Pre-Filed Testimony of Dr. Patrick Lucia

**PCHB No. 01-160
*ACC & CASE v. Dept. of Ecology & Port of Seattle***

February 27, 2002

Figure 6: Moisture Content Variation Over Time for Cross Section 2
Using Hart Crowser Group 3 Embankment Fill Properties

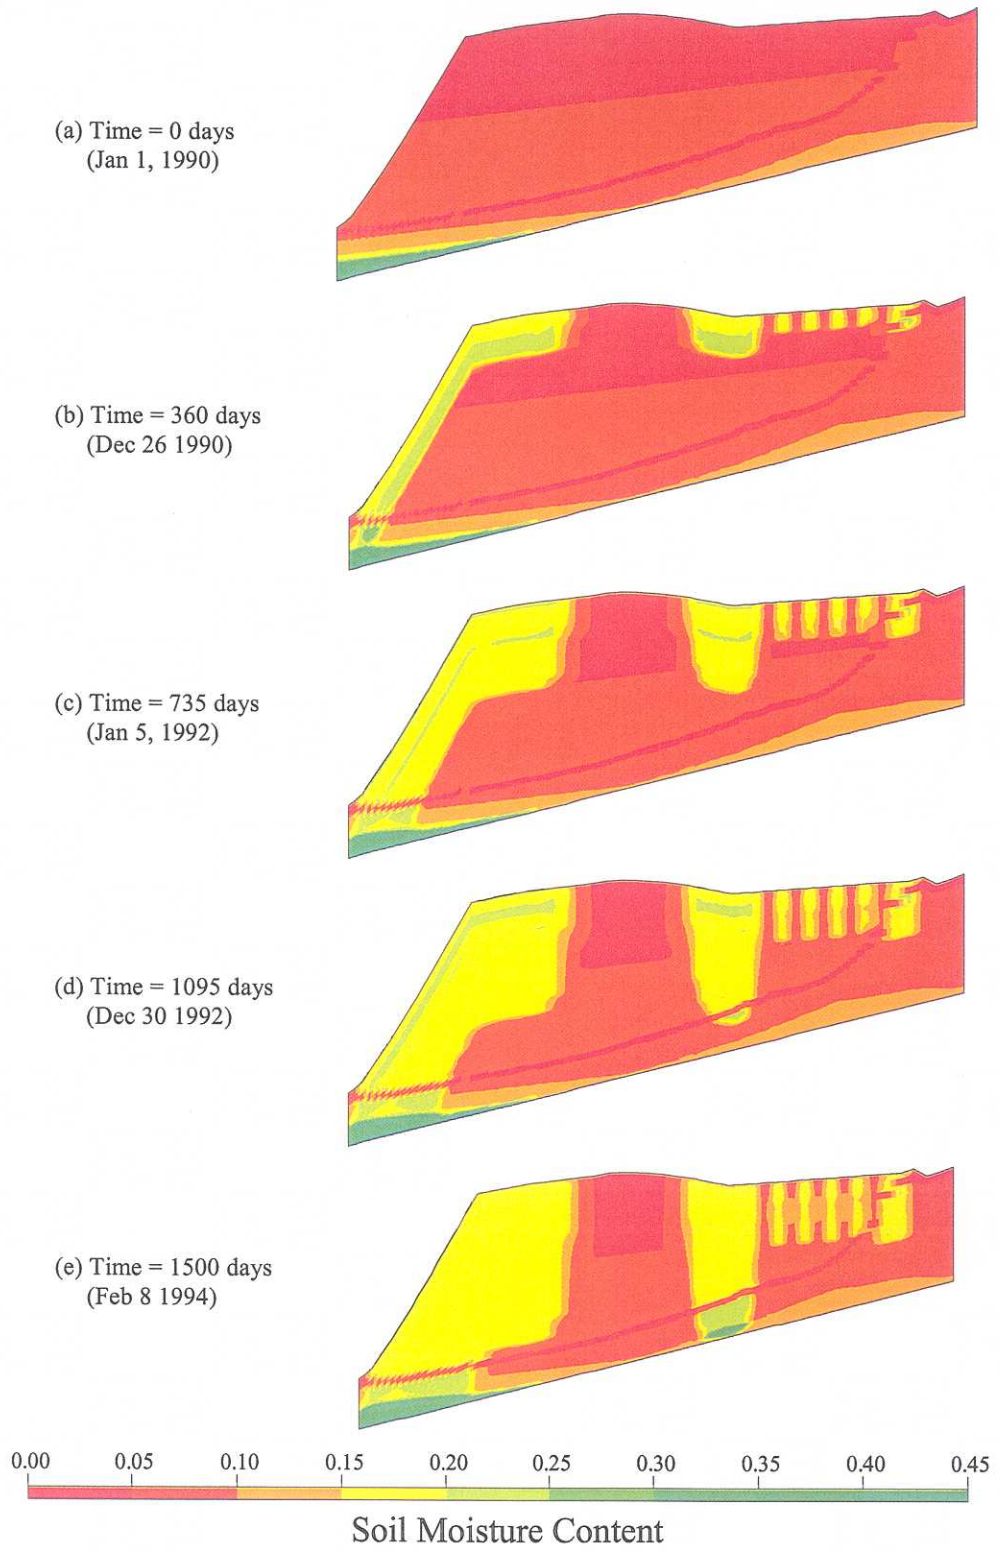
37. Figure 6a presents a schematic of the Hydrus model cross-section being used by GeoSyntec, which is based on PGG's section 2, with an embankment fill height of up to 110 ft. The embankment fill, the drainage layer, the outwash layer, and the underlying till are all being modeled within Hydrus. The model is being run using approximately four years of daily precipitation data (January 1990 through February 1995) from the SeaTac airport. No runoff or evapotranspiration calculation has been made, so all precipitation is assumed to enter the embankment.

38. Figures 6a through 6e present preliminary results using the Hart Crowser Group 3 fill properties. The lighter colored front that progresses downward over time represents the propagation of the infiltrating precipitation. It is clear that the water infiltrating near the face of the slope, which has a shorter travel path to the drainage layer has already begun to reach the drain and then the creek by approximately 1 year after the modeling begins (Figure 6b). However, the flow under the thick majority of the embankment is only beginning to reach the drainage layer between 3 and 4 years (Figures 6d and 6e). With the uniform soil profile assumption relied upon by the Port, there is only slight evidence of horizontal flow of water, although Figures 6b through 6e show a gradual narrowing of the dark colored band of dry soil beneath the runway, indicating that moisture is gradually working its way laterally. This effect can also be seen in the flow of water between the filter strips on the right side of the model. The significance of this lateral flow component is that water will travel within the embankment fill for longer periods of time prior to reaching the

drain and the creeks than with analyses limited to vertical flow only. The Port, using their simplified analyses, has reported none of these trends.

Figure 7: Comparison of 1-Dimensional versus 2-Dimensional Flow in Uniform Fill Columns (25 ft thick) with Port Properties

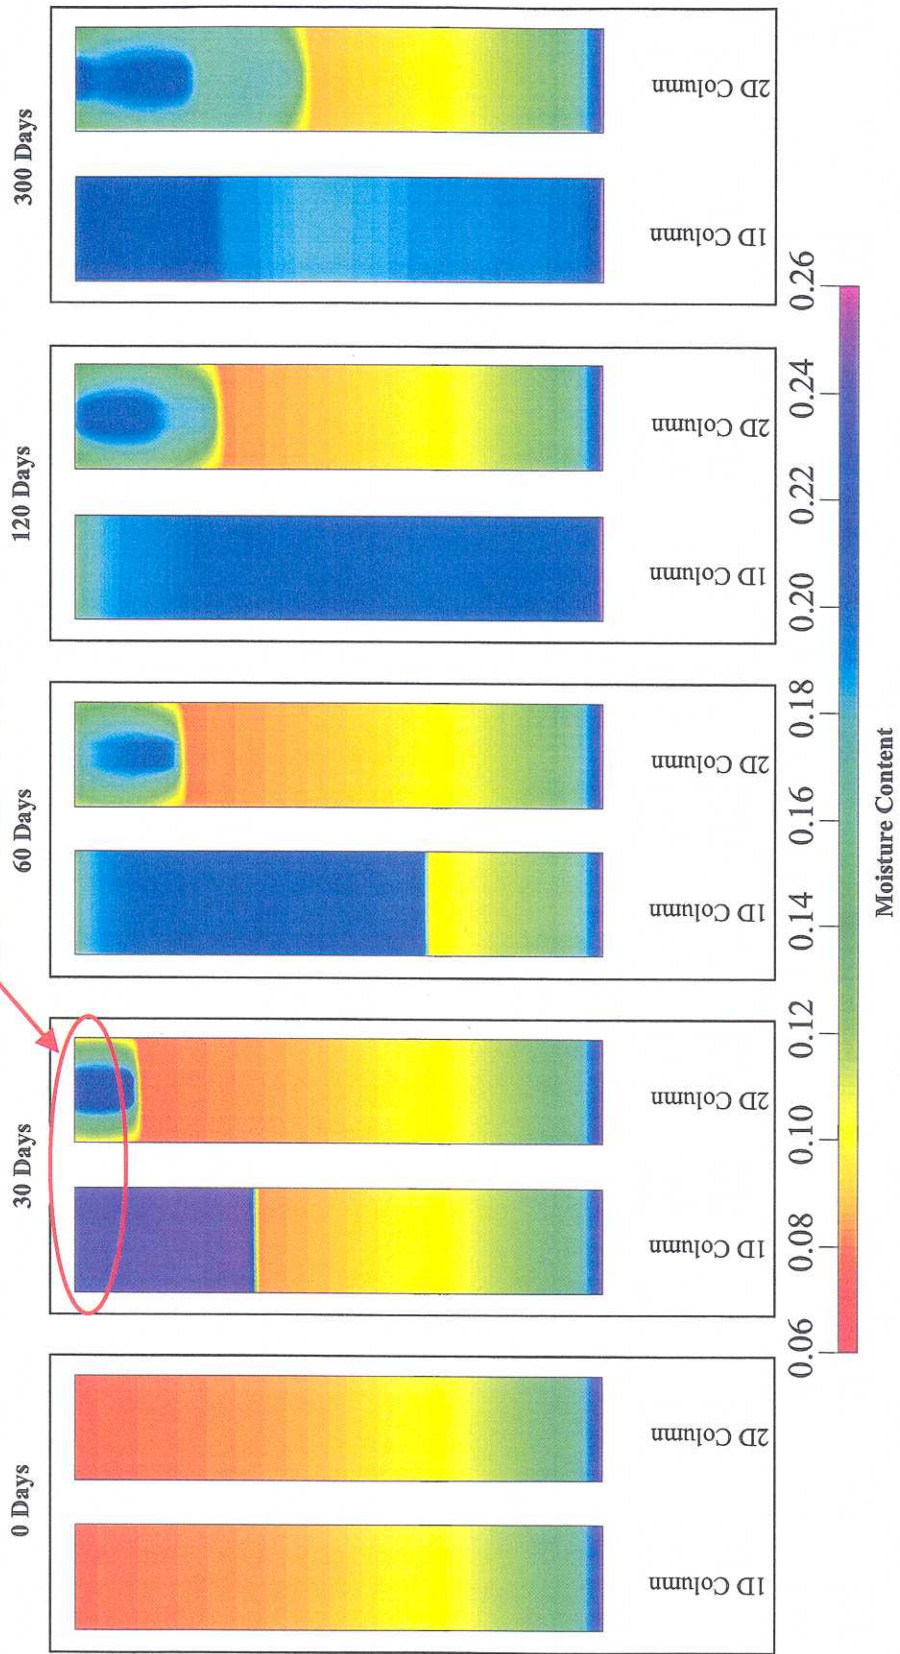
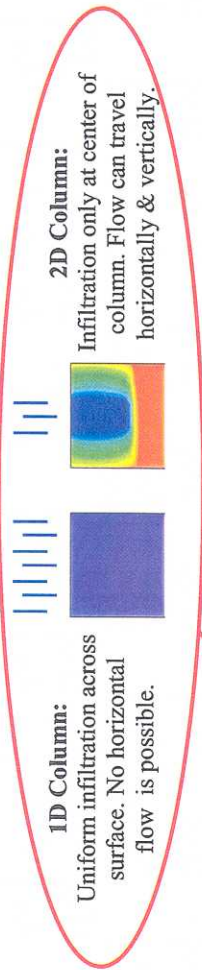
39. To demonstrate the impact of horizontal flow on the travel time of water flowing through the embankment, two sets of analyses were performed using the Port's soil properties as shown on Figure 7. Two 25 ft thick fill columns were modeled in Hydrus, subjected to equivalent rainfall intensities. In the 1-Dimensional (1D) column, water infiltrating at the top of the column travels downward vertically, without an opportunity for any horizontal flow. In the 2-Dimensional (2D) column, water was applied over the middle 2/5^{ths} of the column only, but once the water entered the soil column, it was allowed to travel both vertically and horizontally. This 2-Dimensional scenario is representative of precipitation adjacent to the runway or filter strips (as seen on Figure 6), where water landing directly on the fill surface can pass directly into the embankment, but water landing on the impermeable runway or filter strips cannot.

40. Comparison of the 1D and 2D columns on Figure 7 makes the impact of horizontal flow immediately apparent. After 30 days, while flow in the 1D column has had nowhere to go but downwards (represented by the advancing dark colored wetting front), flow in the 2D column has traveled downwards and laterally (represented by the dark colored center and lighter colored bands spreading outwards both in front and on the sides of the wetting front). By 60 days, the wetting front in the 1D column has traveled approximately two thirds of the distance to the drain, while the 2D column wetting front has only progressed a quarter of the distance to the drain. This trend continues throughout the analysis, as the 1D column can only send water downwards, while the 2D column continues to allow water to fill

in underneath the impermeable regions on either side of the entry point. Clearly, without incorporating this effect into their analysis, the Port is overpredicting the rate at which water flows through the fill, and therefore their estimates of the time at which flows will arrive at the creek will not be representative.
